MANUAL UPDATE

KIDDIE HIMALAYA BULLETIN

KIDDIE HIMALAYA

BOLT REPLACEMENT

LAP BAR INSPECTION PROCEDURE

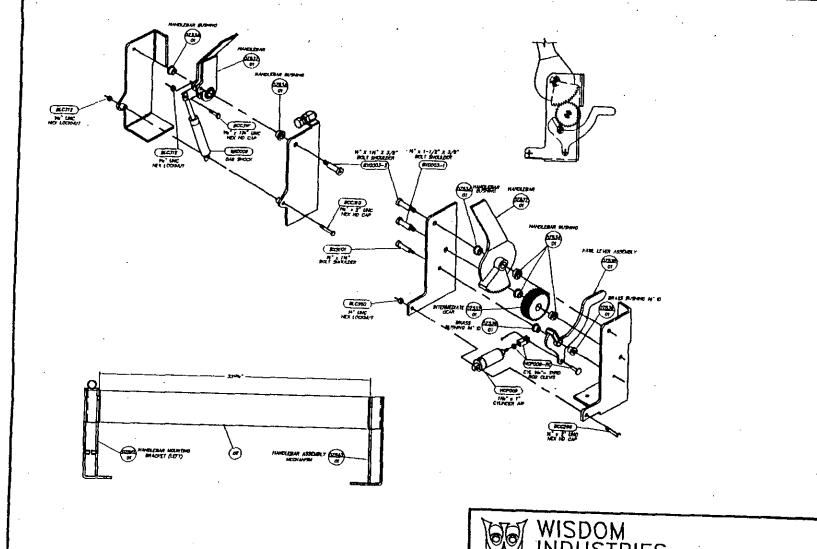
Enclosed is an addition to the current manual on your Family Himalaya.

- 1. Raise lap bar.
- 2. Check lap bar hinge bolts and lock mechanism hinge bolts for looseness or broken bolts.
- 3. Check lap bar air cylinder attachment pins for security and cotter pins.
- 4. Check lap bar arm for cracks.
- 5. Check that the lap bar foam is centered and in good shape.
- 6. Lift lap bar manual release.
- 7. Push down lap bar. Lap bar must ratchet down and lock at each detent.
- 8. Activate air unlocking system. NOTE: All bars should raise.
- 9. Turn off air unlocking system.
- 10. Watch as the air is released that the seat manual release lever does not stick or operate in a jerky manner.
- 11. Check that air cylinder mechanism releases so that bar will lock.
- 12. Push down lap bar. Lap bar must ratchet down and lock at each detent.
- 13. Repeat for each seat.

Weekly
Oil all hinge bolts.
Oil lock gear pivot bolts.
Oil air unlocking cylinder pivot pins.
Grease gear teeth.
